Change Order

PROJECT <i>(Name and address):</i> Rapid City Utility Maintenance Facility Rapid City, South Dakota	CHANGE ORDER NUMBER: 003 DATE: April 15, 2015	OWNER: <input checked="" type="checkbox"/> ARCHITECT: <input checked="" type="checkbox"/> CONTRACTOR: <input checked="" type="checkbox"/> FIELD: <input type="checkbox"/> OTHER: <input type="checkbox"/>
TO CONTRACTOR <i>(Name and address):</i> SECO Construction, Inc. P.O. Box 2921 Rapid City, SD	ARCHITECT'S PROJECT NUMBER: 13373 CONTRACT DATE: September 17, 2014 CONTRACT FOR: General Construction

Construction Change Directive

PROJECT: <i>(Name and address)</i> Rapid City Utility Maintenance Facility Rapid City, South Dakota	DIRECTIVE NUMBER: 002 DATE: April 6, 2015 CONTRACT FOR: General Construction	OWNER: <input checked="" type="checkbox"/> ARCHITECT: <input checked="" type="checkbox"/> CONSULTANT: <input type="checkbox"/> CONTRACTOR: <input checked="" type="checkbox"/> FIELD: <input type="checkbox"/> OTHER: <input type="checkbox"/>
TO CONTRACTOR: <i>(Name and address)</i> SECO Construction, Inc. P.O. Box 2921 Rapid City, SD 57709	CONTRACT DATED: September 17, 2014 ARCHITECT'S PROJECT NUMBER: 13373

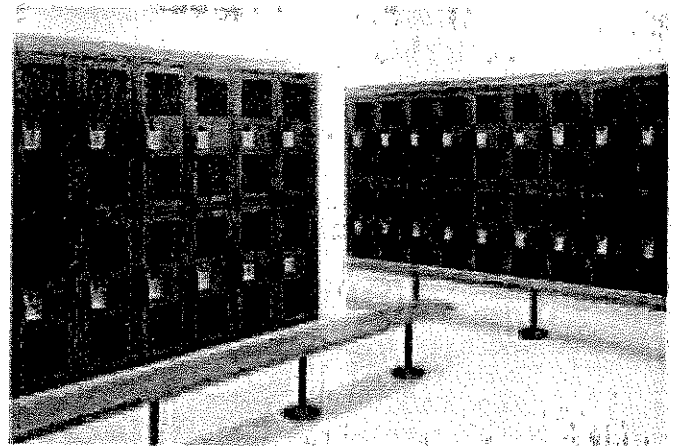
Provide cost credit to provide and install Republic Heavy Duty Ventilated lockers with doors in lieu of Open-Front Gear lockers as specified. All components shall remain unchanged.

PROJECT NO. 13028		DRAWN BY ELH		CHECKED BY S.A.F		DATE: 3-26-15	
PROJECT TITLE CITY OF RAPID CITY UTILITY MAINTENANCE FACILITY		SHEET TITLE PLUMBING PLAN		SHEET MSK17-1		REF SHEET: M-101

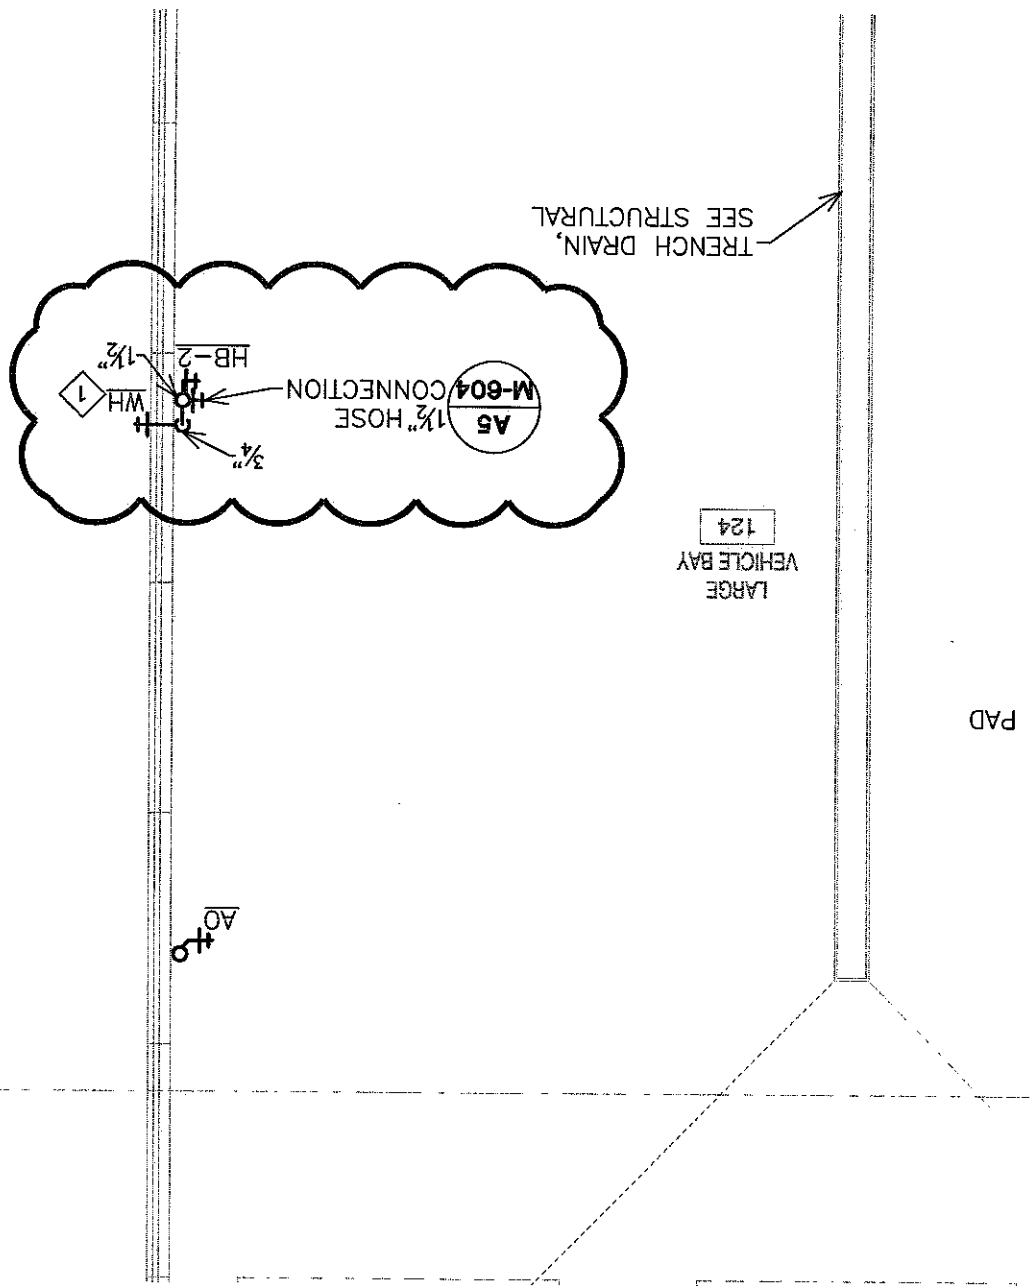
Background: Owner has requested an additional 1 1/2" fill station be added to East wall of Large Vehicle Bay 124.

1. Provide 1 1/2" DCW piping as indicated on attached sketch. Intent is delete shown 3/4" line as indicated and replace with 1 1/2". Provide hose connection and all materials/equipment that is called out on detail A5/M-604. The requirement for the hose bib (HB-2) and wall hydrant (WH) in the drop location of the new fill station will still be needed. Provide fittings and piping as required to connect to new 1 1/2" fill line.

PROJECT NO. 13028		DRAWN BY ELH		CHECKED BY S.A.F		DATE: 3-26-15	
PROJECT CITY OF RAPID CITY		UTILITY MAINTENANCE FACILITY		SHEET TITLE		PLUMBING PLAN	
PROJECT SHEET		M-101		REF SHEET:		M-101	
PROJECT SHEET		M-101		REF SHEET:		M-101

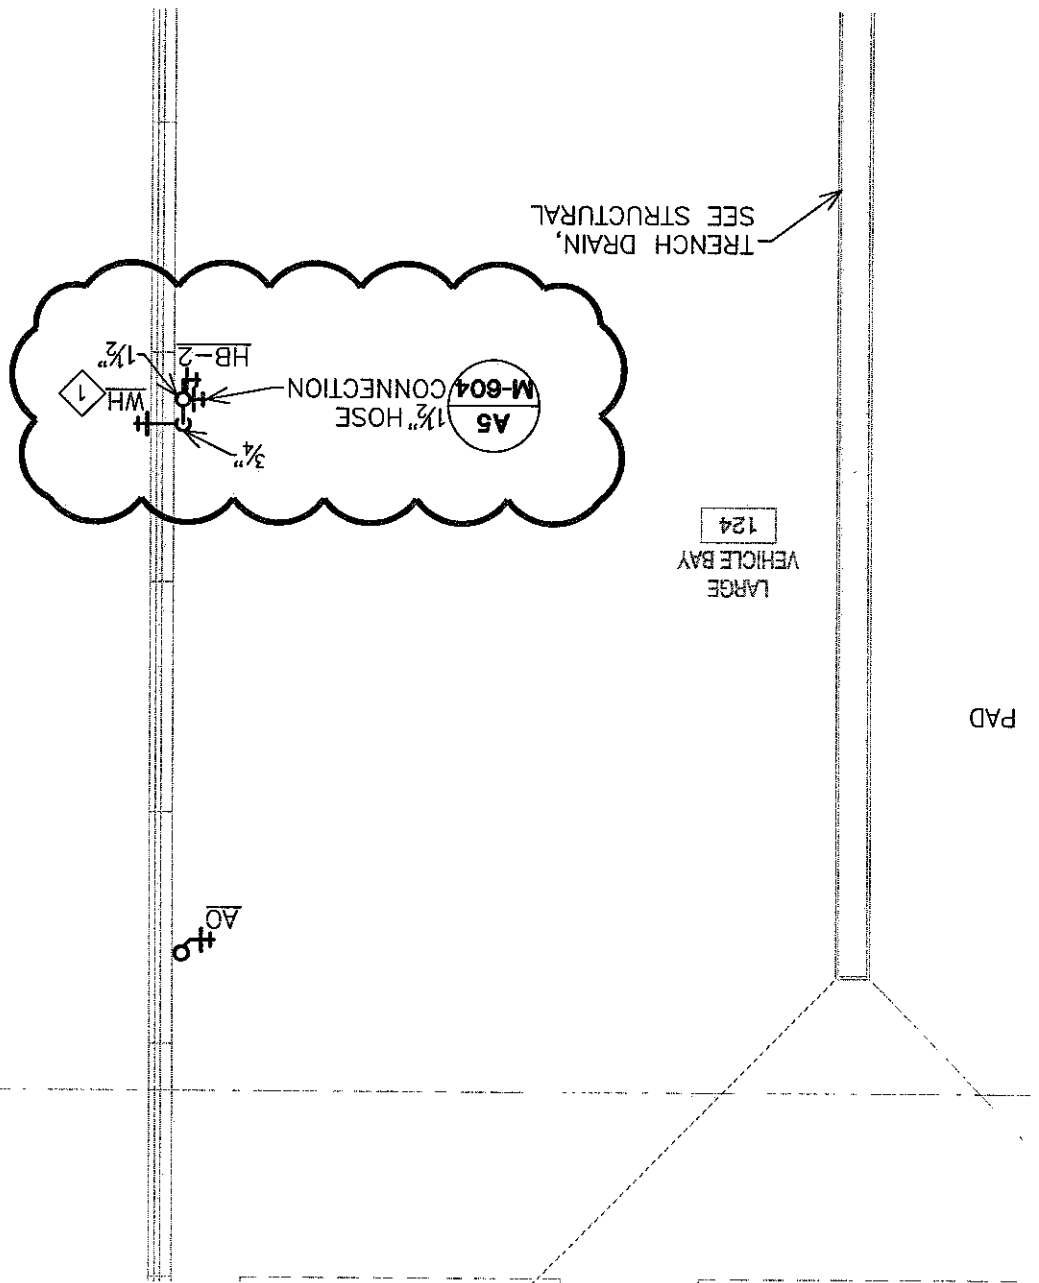
Background: Owner has requested an additional 1 ½" fill station be added to East wall of Large Vehicle Bay 124.

1. Provide 1 ½" DCW piping as indicated on attached sketch. Intent is delete shown ¾" line as indicated and replace with 1 ½". Provide hose connection and all materials/equipment that is called out on detail A5/M-604. The requirement for the hose bib (HB-2) and wall hydrant (WH) in the drop location of the new fill station will still be needed. Provide fittings and piping as required to connect to new 1 ½" fill line.
